517 W. MAIN ST.

CITY PROJECT NO. 15350
CONTRACT NO. 9552

REVISION 1 - 08/18/2025
- UPDATED SHEETS: U1

15350	MADISON, WI	9552	CONTRACT NO:
UTILITY PLAN & PROFILES			
517 W MAIN ST.			
15350			
U-1

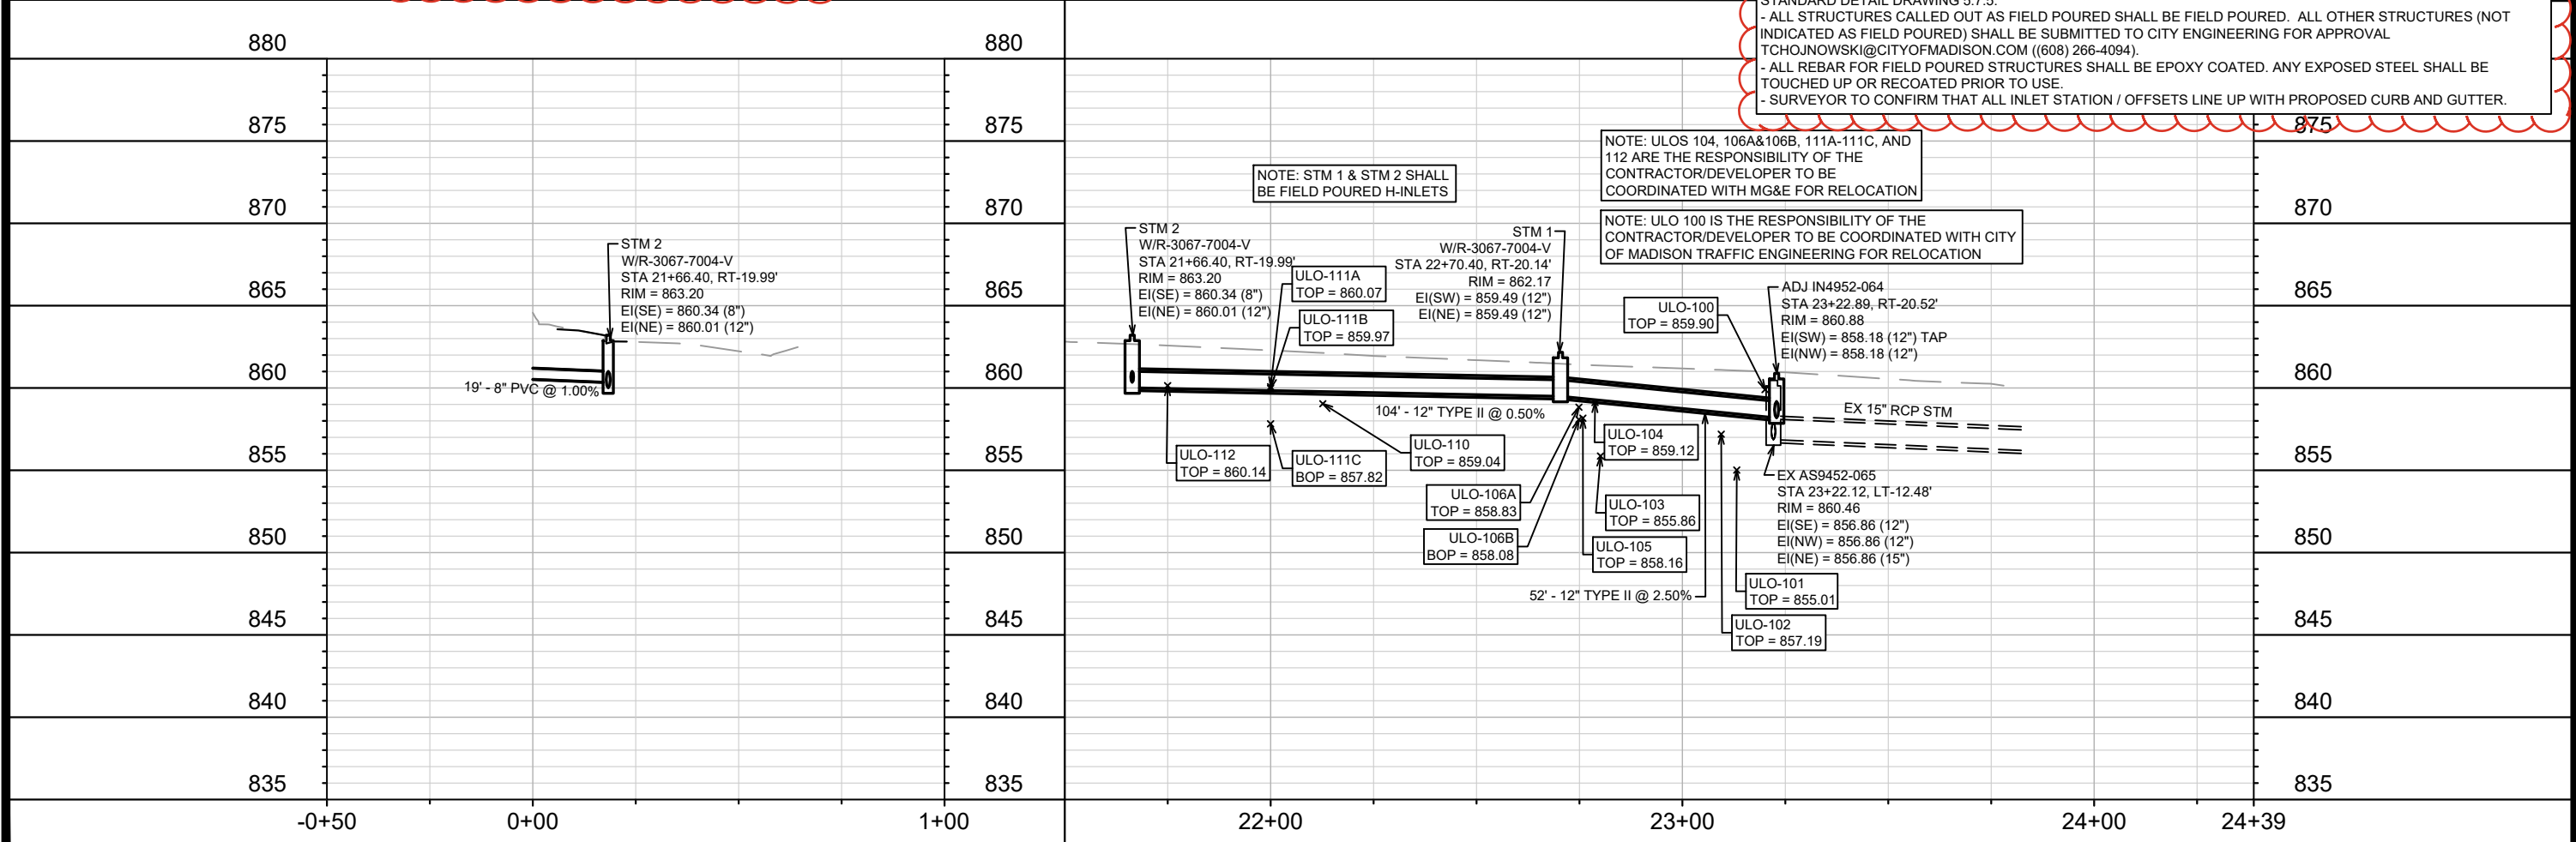
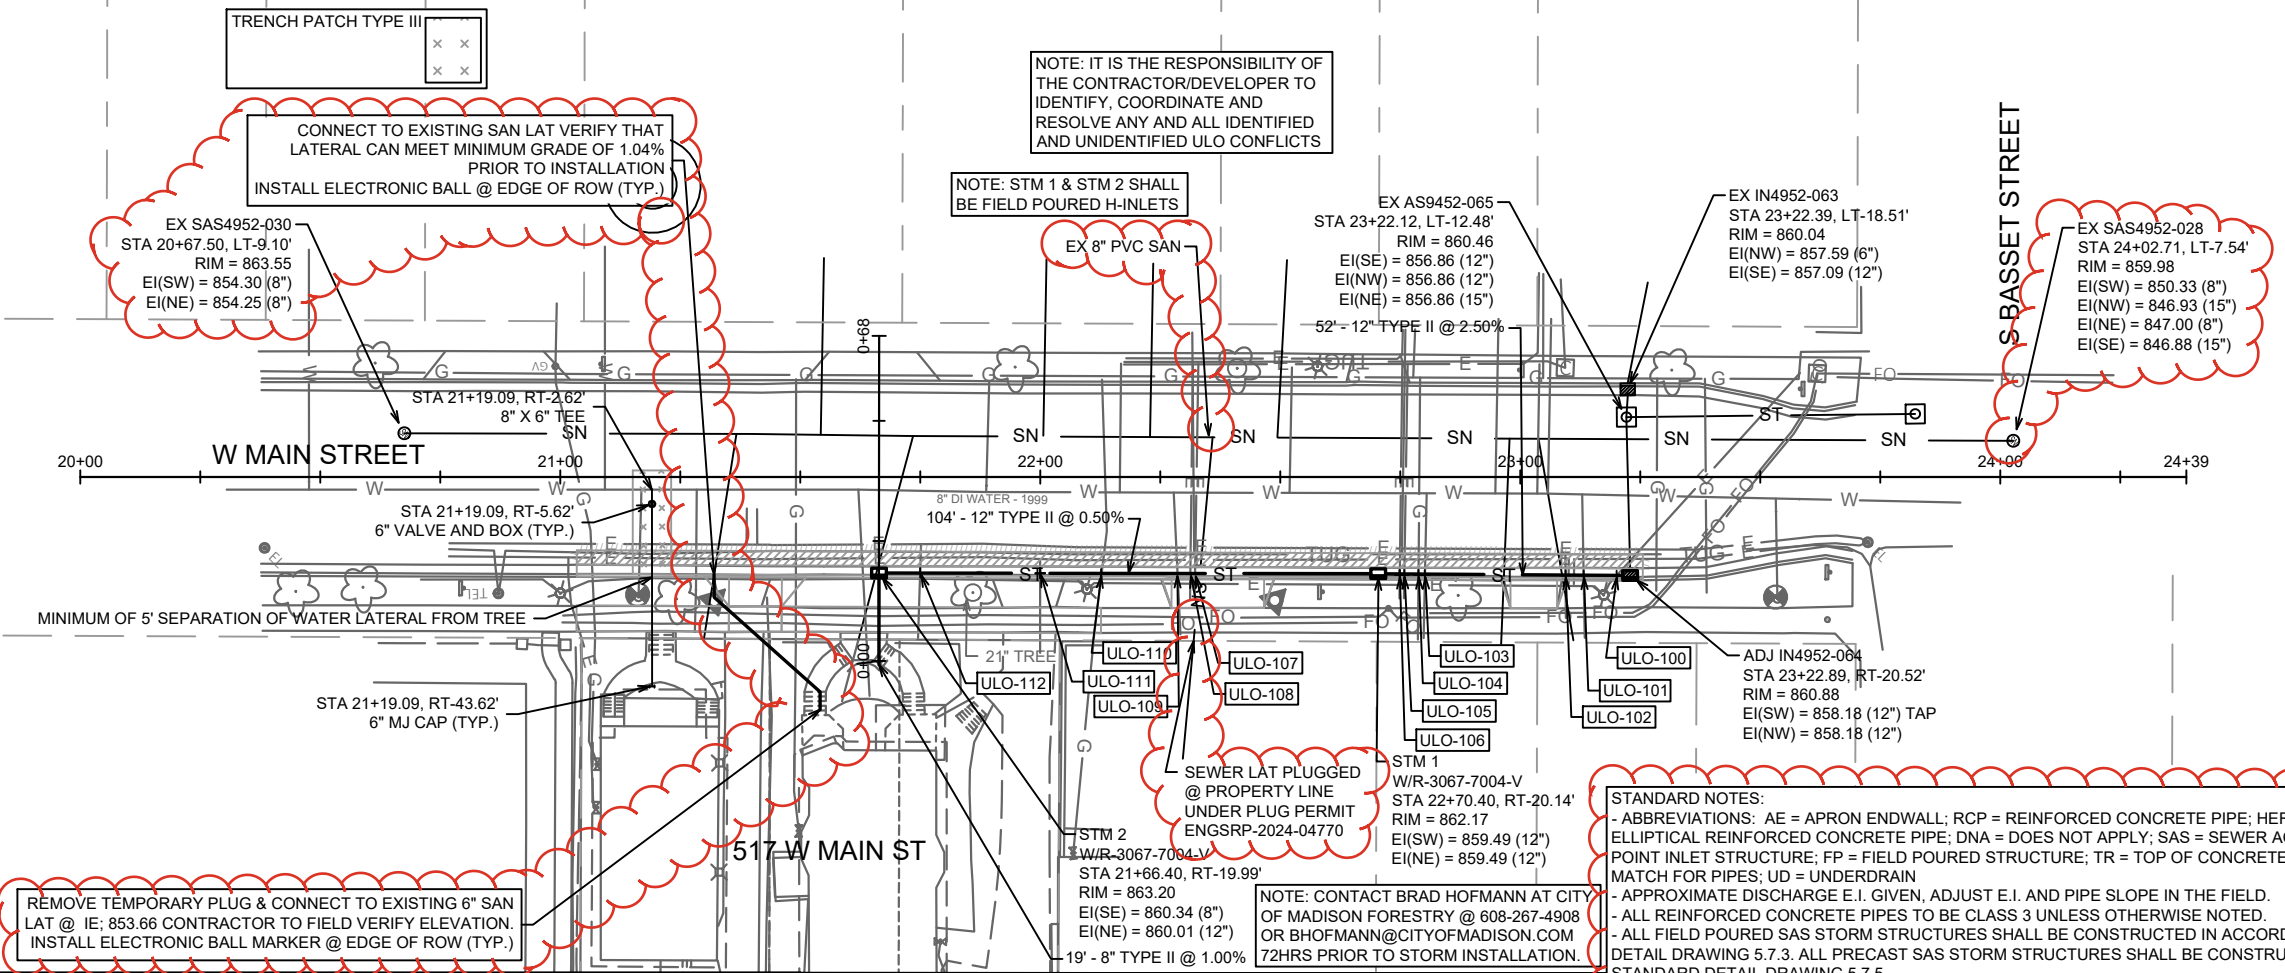
REV 1: TAC 8/18/2025
SANITARY LATERAL
UPDATED LOCATION
